## PCN Letter (Product Change Notification)

This letter is to inform you that M-series Gen2 is planned to change the design

- Product Model: M-series Gen2
- Part Number: Please refer to the Appendix#1

[Outline of PCB board]

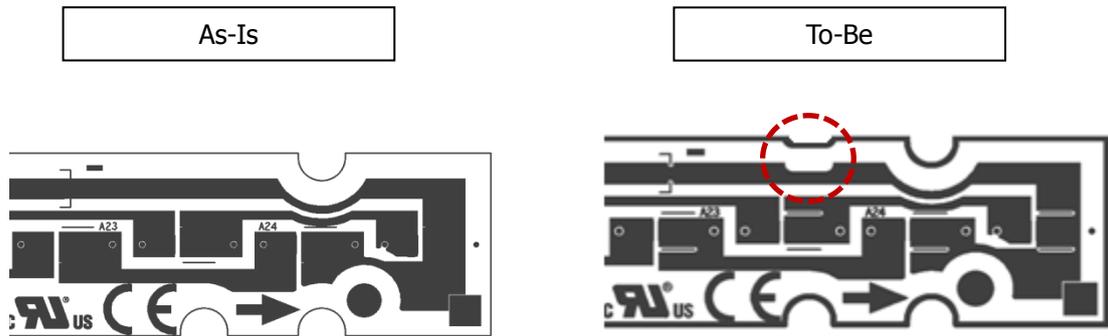
No.	Item	Change point
1	Outline of PCB	Notch added
2	Width of power traces near notch	Reduced to meet Creepage distance
